Raiyan Knit Composite Ltd. Noor Group Ltd.

Hortokitola, Chandra, Kaliakoir, Gazipur
(24.050241N 90.234168E)

26 APRIL 2014

Observations

BUILDING 1: Heavy loaded column.

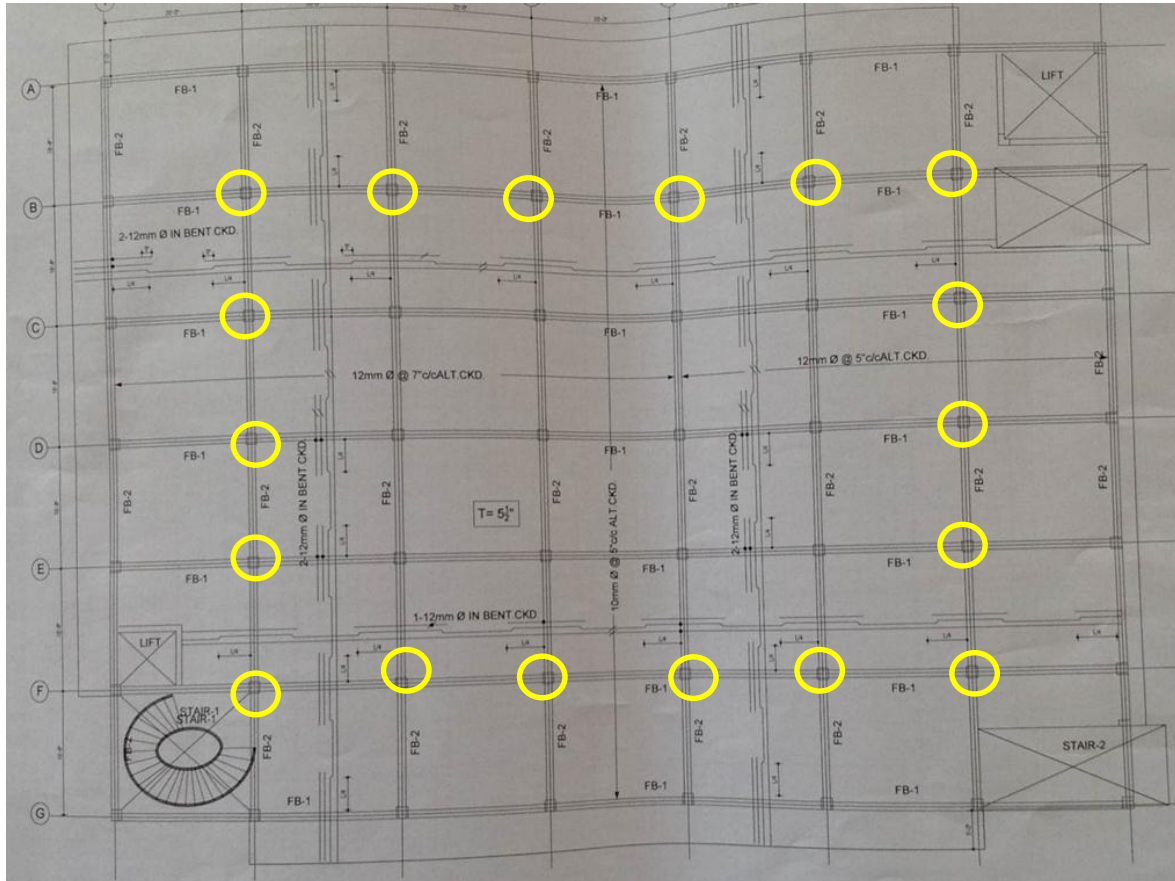
Highlighted columns appear to be stressed to high levels.

BUILDING 1: Flat slab thickness.

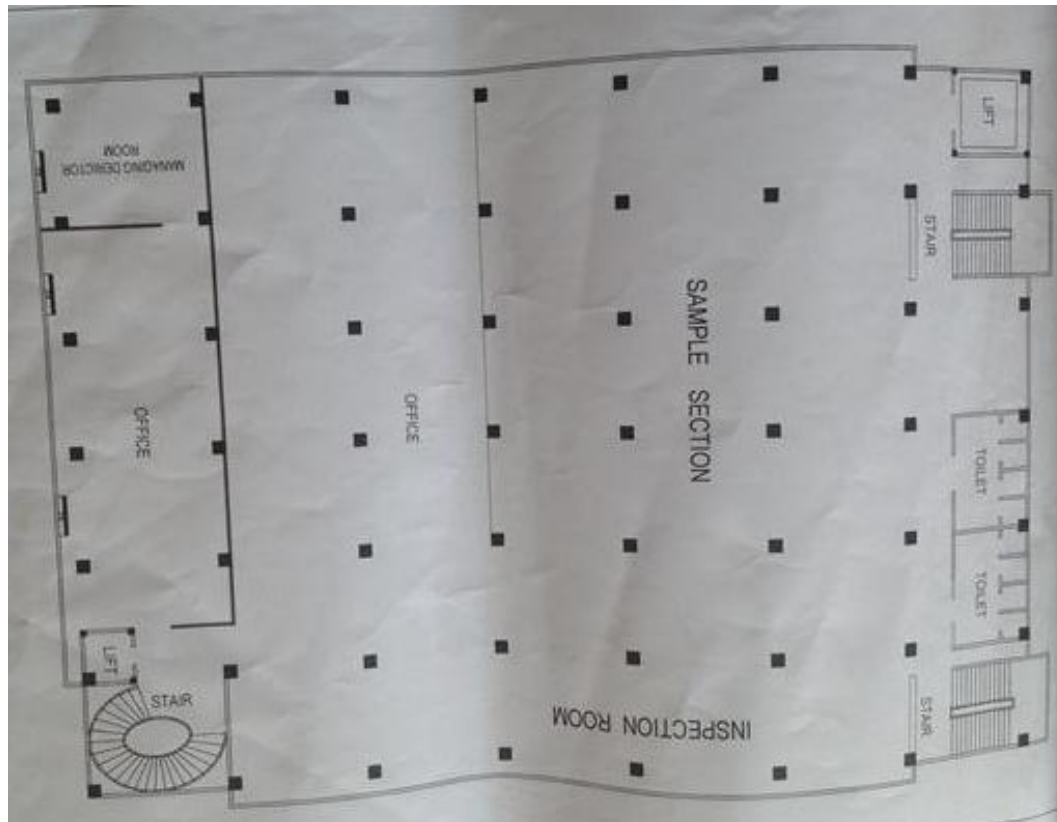
The thickness for the flat slab is given as 165mm (6.5inch) on the structural drawing. On site we measured about 180mm but this considers a thin slab for the 6.1 x 5.1m grid. Concern with punching shear and bending. Partitions is to be considered in the design. Load limits resulting from the calculations are to be recorded and loading plans produced.

BUILDING 1: Structural drawings for cantilever façade on building 1 do not match current arrangement of the structure.

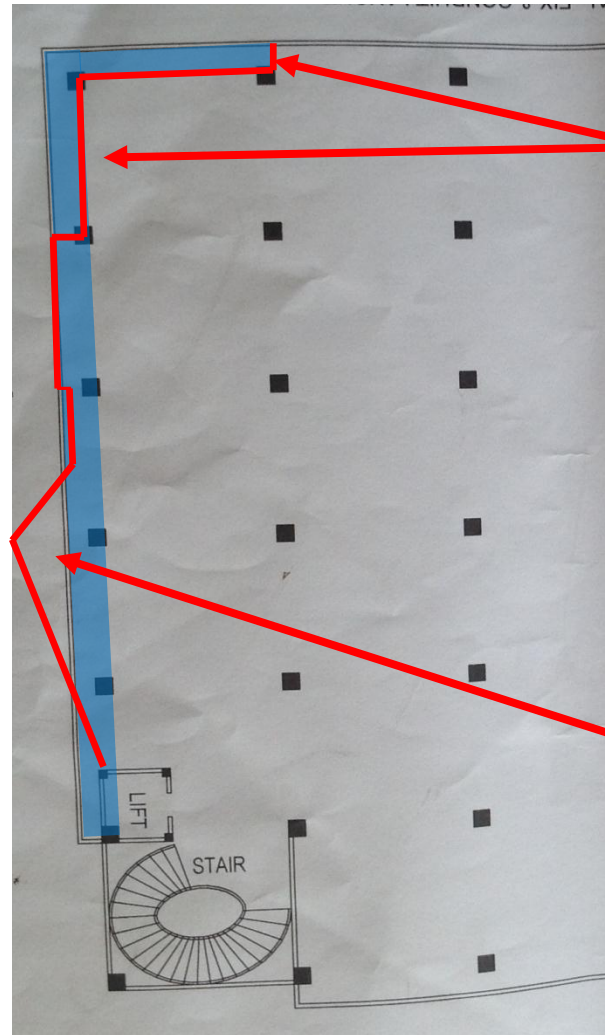
Building façade outline differs to what is shown in drawings for several floors. Since only one typical reinforcement drawing was provided for all flat slabs and one typical drawing for both beam-slabs the slab reinforcement needs to be justified by calculation. The different cantilever lengths do have an influence on the required reinforcement

Façade cantilever extends to maximum 2.575m

BUILDING 1: No documentation for two RC columns supporting stair core and the foundations for the lift cores

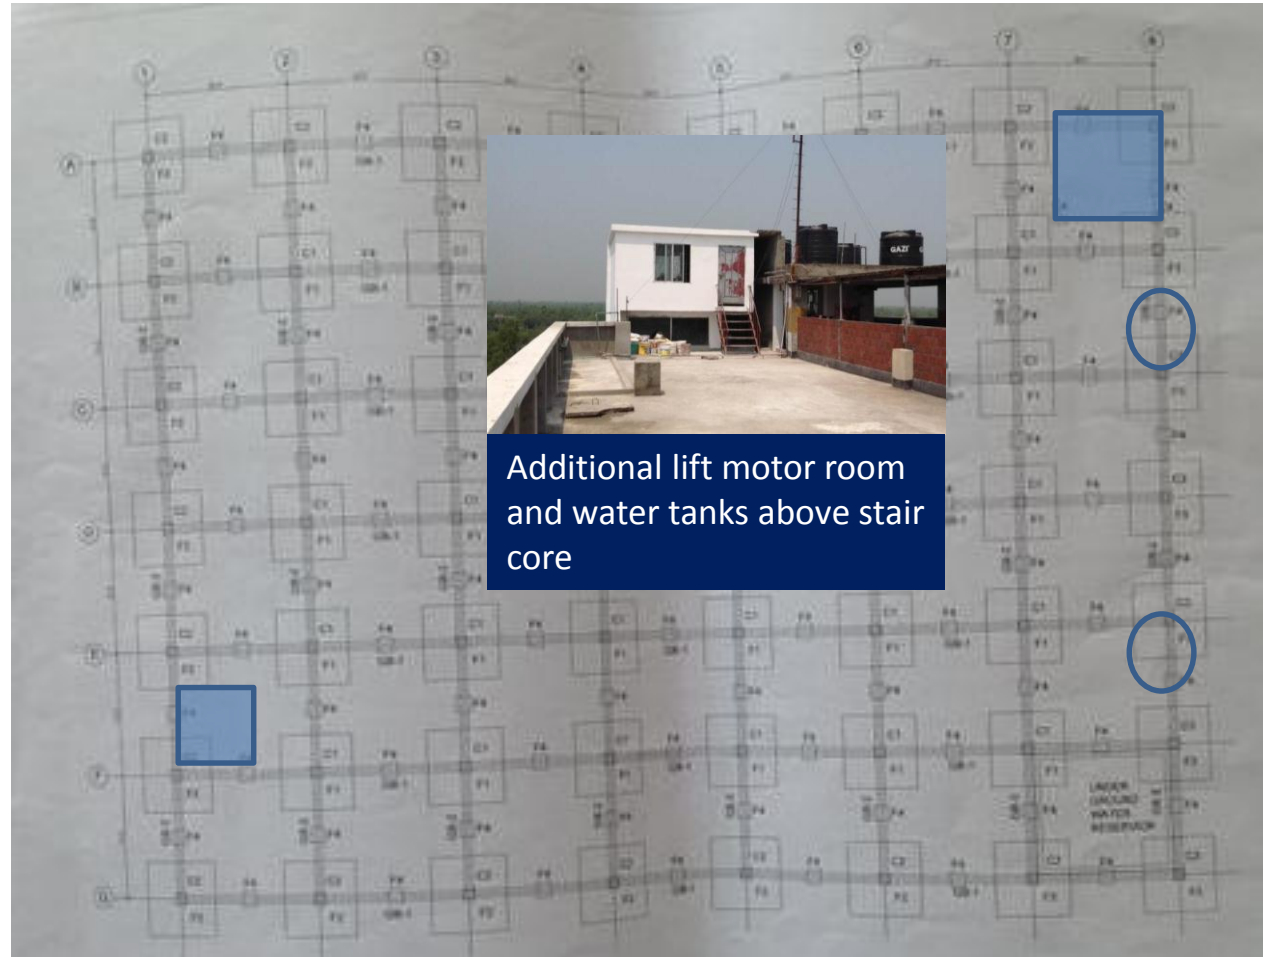
The foundation drawing does not include any information on the foundation for the lift cores. Reportedly done as a raft foundation.

The stair cores at the back of the building have an additional RC columns (confirmed by taking off plaster), which is not shown on the drawings

8	BUILDING 1: RC cover plate under external façade to cover up electrical cables	Replace slab with new lightweight metal cable tray. Ensure proper fixing to façade and external building wall.	Immediate - Now
9	BUILDING 1: Foundation drawings do not show footings below columns located around lift shafts and stair core. Undocumented columns in wall of stairwell	Building engineer to check, collect information and produce accurate and complete as-built documentation soonest. Note: the loads should also include the water tanks and the additional lift motor building recently built	6-months

BUILDING 1: Additional structures at roof level (above the lifts)

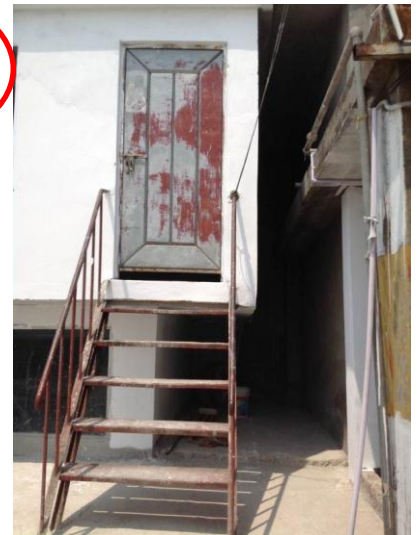
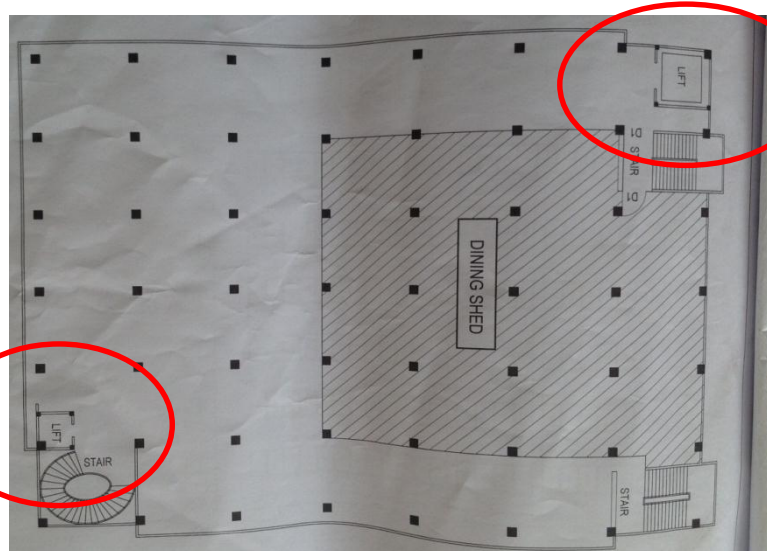
Lift shaft motor room not in original drawings.

Both comprise cantilever slabs / structures.

BUILDING 2: Cantilever slab at movement joint locations.

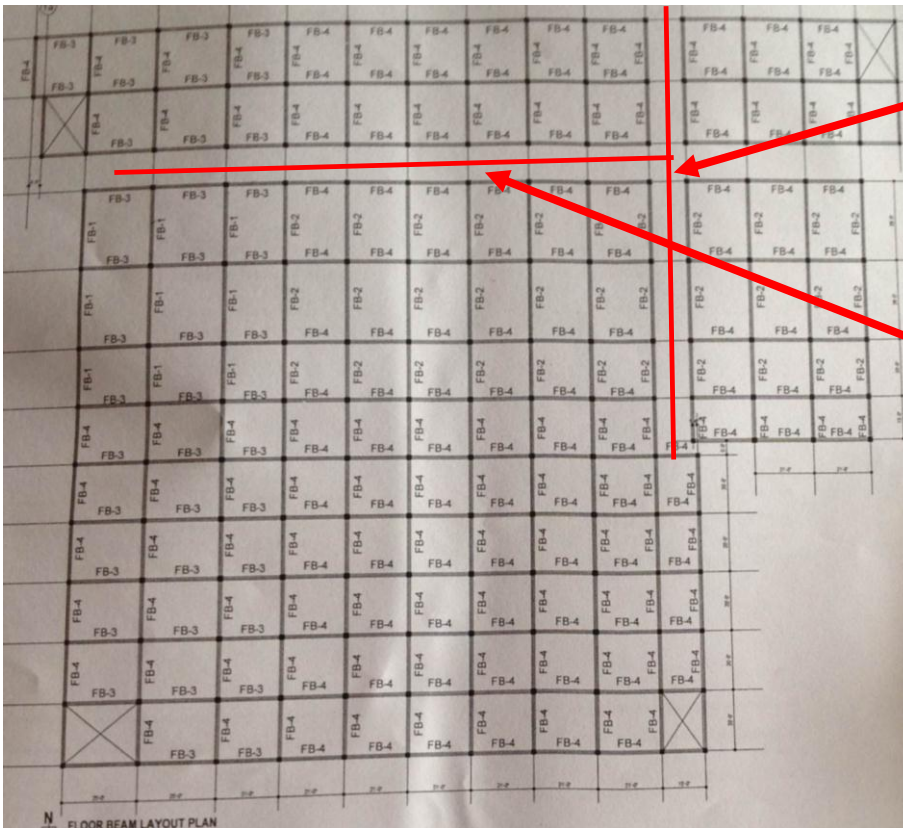
Column and facade at end of corridor (gridline 6) is not supported below and hence provides additional dead load to one side of the cantilever

15	BUILDING 2: Cantilever slab at movement joint locations.	Assess the design floor load (imposed live load) on the 2m long cantilever and clearly mark the areas accordingly.	6-weeks

BUILDING 2: Stability of building part J-M/1-6

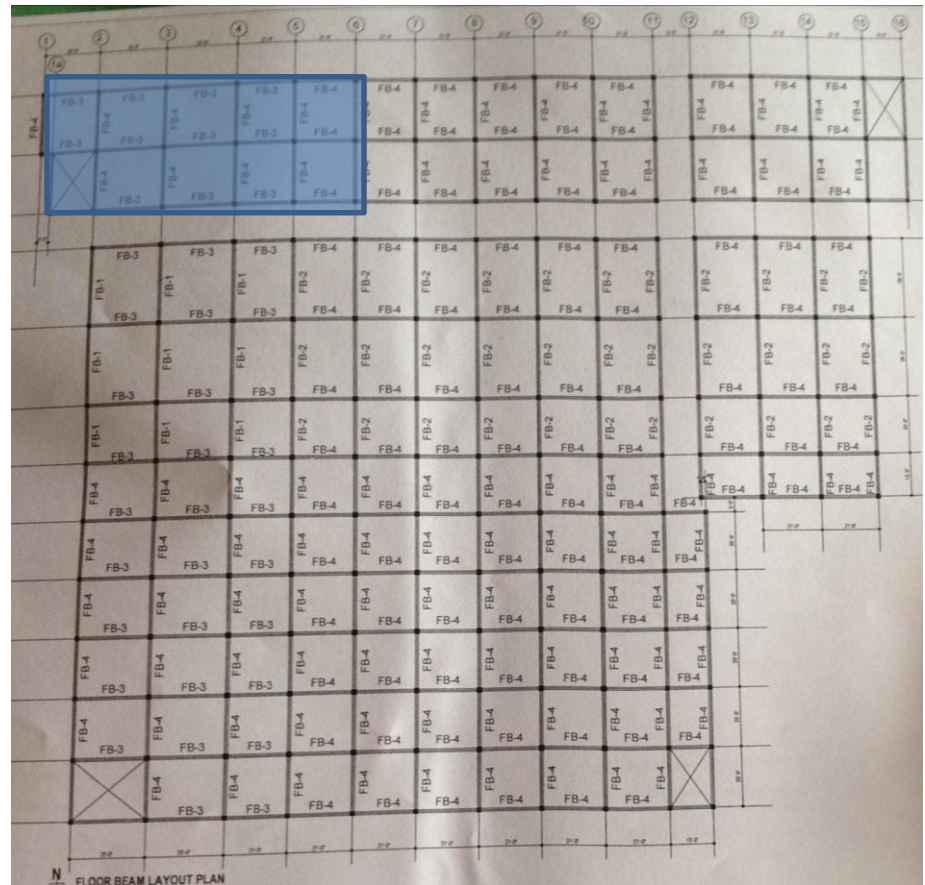
Stability for the highlighted building part (gridline J-M / 1-6) is only provided in short direction by a moment frame with 2 spans (3 columns). Moment frame should therefore be checked for adequacy.

Item No.	Observation	Recommended Action Plan	Recommended Timeline
16	BUILDING 2: Stability of building part J-M/1-6	Structural checks for adequacy of stability frame.	Immediate - Now
17	BUILDING 2: Stability of building part J-M/1-6	Design of strengthening elements if required (we currently do not see any reason why the buildings have to be separated by movement joints in 3 parts. Strengthening could just mean to connect the slabs)	6-weeks
18	BUILDING 2: Stability of building part J-M/1-6	Implementation of strengthening elements if required.	6-months
19	STEEL SHED: Stability of steel shed	DO NOT USE IN STRONG WIND CONDITIONS.	Immediate - Now
20	STEEL SHED: Stability of steel shed	Building engineer to design temporary measures to stabilise the building (e.g. diagonals)	Immediate - Now
21	STEEL SHED: Stability of steel shed	Implement the temporary measures to stabilise the building	6-weeks
22	STEEL SHED: Stability of steel shed	Replace temporary measures with a permanent design or remove the shed.	6-months
